**FINAL ENVIRONMENTAL
IMPACT STATEMENT
FOR THE PROPOSED
CENTRAL MONTANA
100-KV TRANSMISSION
PROJECT**

EXECUTIVE SUMMARY

In November, 1984, the Department of Natural Resources and Conservation (DNRC) released its draft environmental impact statement (EIS) on the Montana Power Company (MPC) proposed 100-kV transmission line project from Judith Gap to a substation near Glengarry. This final EIS summarizes and updates the draft, contains a chapter consisting of comments and questions pertaining to the draft EIS and DNRC's response to these, and a final chapter of DNRC's conclusions and recommendations to the Board of Natural Resources and Conservation (Board). A 30-day comment period followed issuance of the draft EIS and ended on December 7, 1984. DNRC held a public meeting in Moore on December 5, 1984, to gather comments. DNRC used the comments in preparing this final EIS. Most are responded to directly in Chapter Four. The remainder are addressed in Chapter Three.

FIGURE 1
LINE LOCATION OPTIONS*

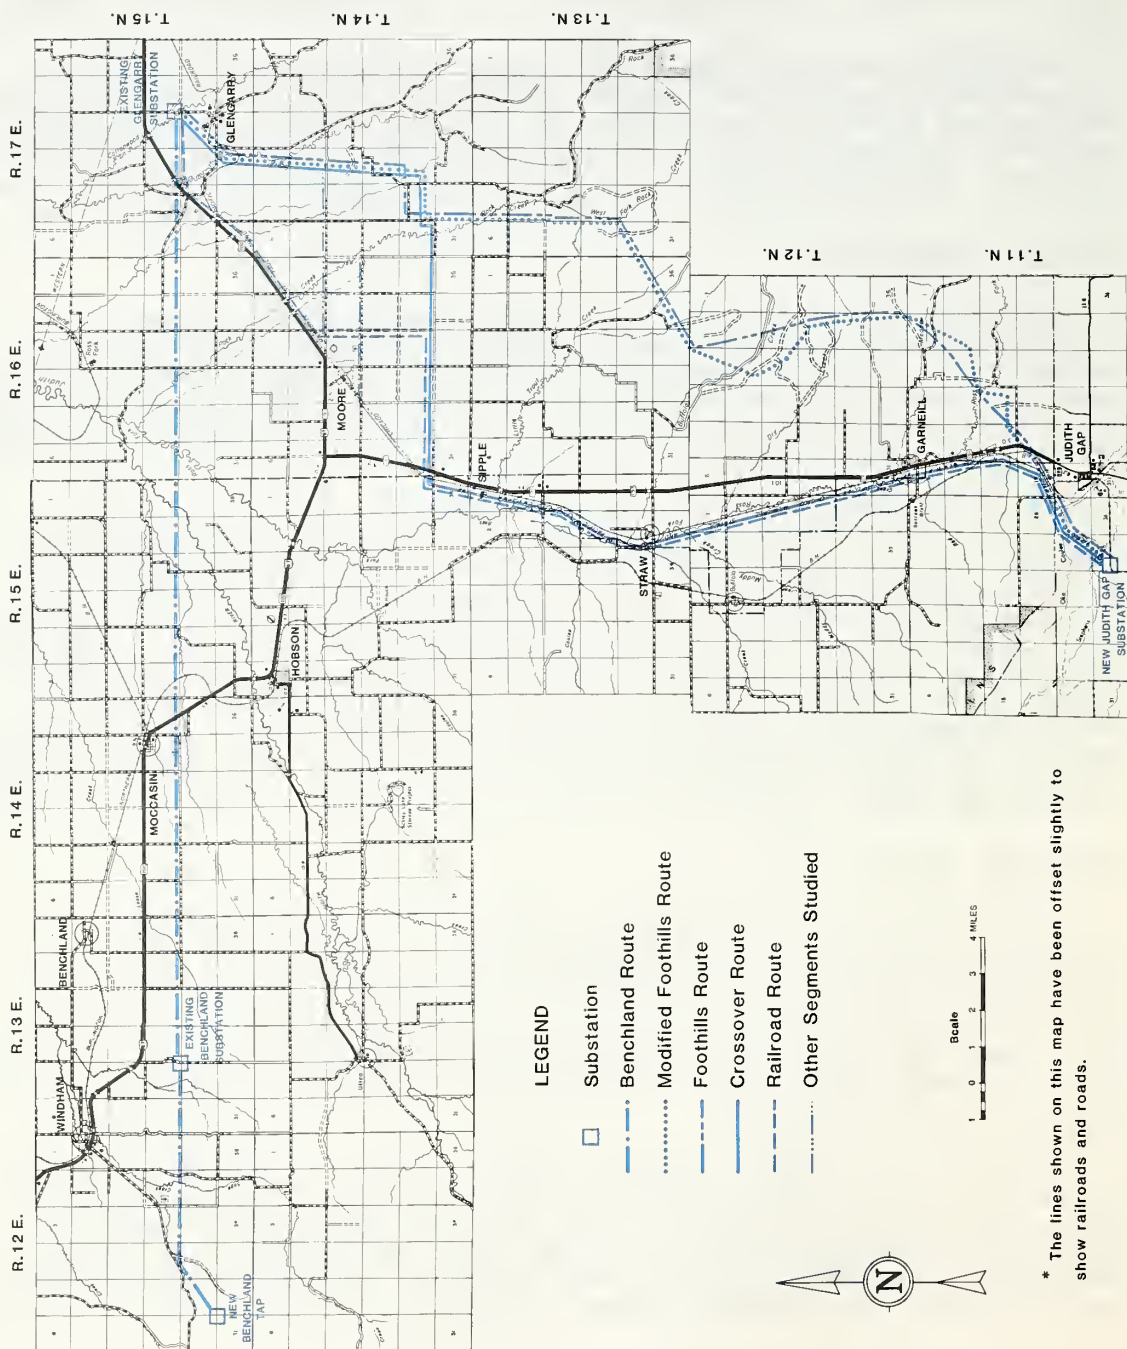
COMMENT: The differences between the Foothills Route and Modified Foothills Route for dry cropland crossed and railroad and county road right-of-way used as shown in the draft EIS, Table 2, page 30, should be more nearly the same, given the route refinements applied by DNRC. (MPC)

COMMENT: The Crossover Route appears to go through Garneill and Straw affecting all residences there. What happened to Sipple? (MPC)

COMMENT: The Foothills Route as plotted in Figure 1, page 2, of the draft differs from MPC's route in T 13N R16 and 17E. The EIS does not mention a route refinement in this area and Figure 1 may be in error. (MPC)

COMMENT: The route adjustment shown on Figure 1, Page 2, of the draft EIS in the East Buffalo Creek area should start approximately 1.5 miles farther south than where shown. (MPC)

RESPONSE: DNRC agrees. In response to this comment, DNRC remeasured all categories of land crossed by the routes shown on Figure 1. This information and discussion is presented in Chapter Three.

RESPONSE: The only structure in Sipple is a grain elevator. Two houses are located a quarter mile south of the elevator. Sipple was included on Figure 1 as a point of reference but was not considered to be a townsite. The homes located near the Sipple elevator were included in the DNRC's aesthetic analysis of the Crossover Route which is summarized in Table 2, page 30 of the draft EIS.

RESPONSE: DNRC agrees. The Foothills Route as shown on Figure 1 is in error. This error was made in preparing the map for publication. This error has been corrected as shown on Figure 2 printed in this document. However, DNRC's analysis of the Foothills Route was based on the route specified by MPC and drawn on USGS quadrangle maps. The map error in the draft EIS did not affect this analysis.

RESPONSE: The original location and the change suggested in the comment is included in Figure 2 of this document. The location depicted on Figure 1 and discussed in the text of the draft EIS was intended to show an adjustment across property of a landowner who expressed concern over the original location. The change suggested in the comment was not discussed with adjoining landowners. DNRC acknowledges that additional adjustment in this area could further improve the final location of a centerline on this portion of the Foothills Route. If this route were selected, DNRC would contact adjoining landowners in the East Buffalo Creek area regarding placement of a centerline on their property. This study would occur during final centerline evaluation.

FIGURE 2
ROUTES BETWEEN JUDITH GAP AND GLENGARRY SUBSTATIONS *

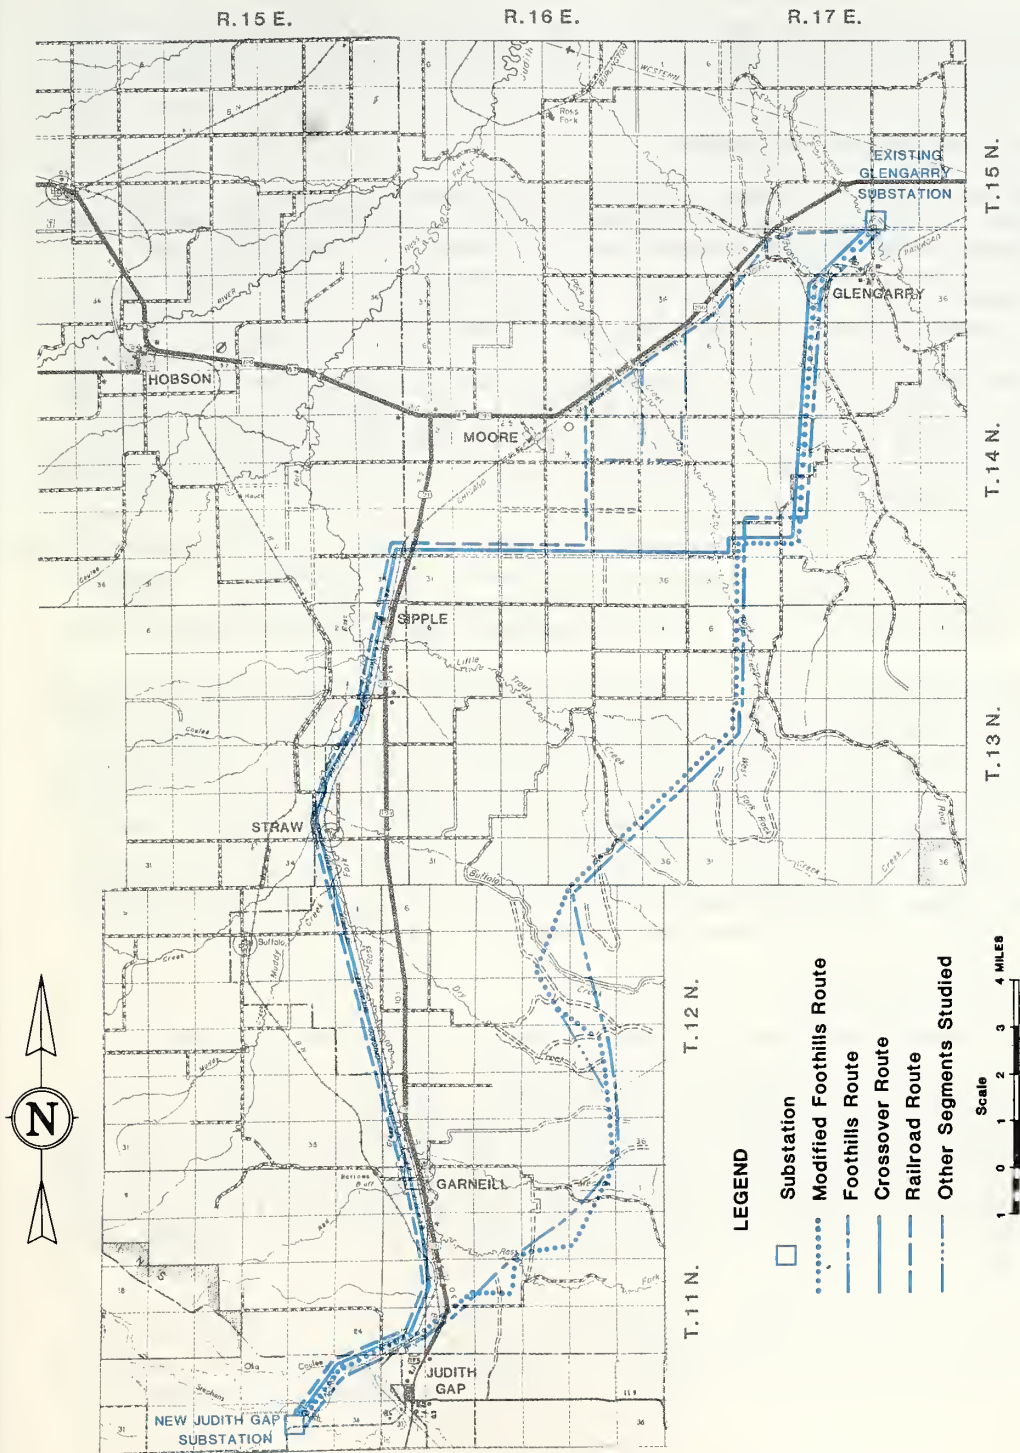
Two alternative routes were presented in written comments and at a public meeting on the draft (see Figure 2). These alternatives were originally investigated by DNRC in the field but not selected as alternatives either for further study or as part of the route analysis presented in the draft. Although both alternatives would locate the line farther from the Moore airstrip, the effect would be minimal since the Moore airstrip has not been operated for some time and has been removed from state aeronautic charts. DNRC agrees that the Moore airstrip does not pose any constraint on the line along the original Railroad Route, contrary to the suggestion in the draft EIS.
